MODEL
XJ Range

NUMBER
S724
ISSUE: 2

TECHNICAL BULLETIN

SERVICE ACTION S724: Constant Battery Drain

Figure 4

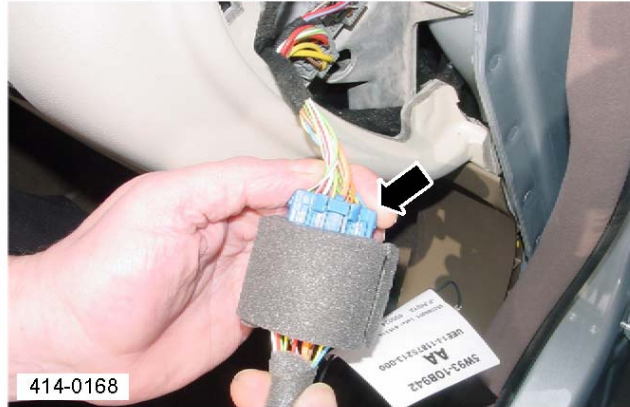
4. Install the link lead (C2C32824) between the blue electrical harness connector and the dash connector block. (Figure 4)
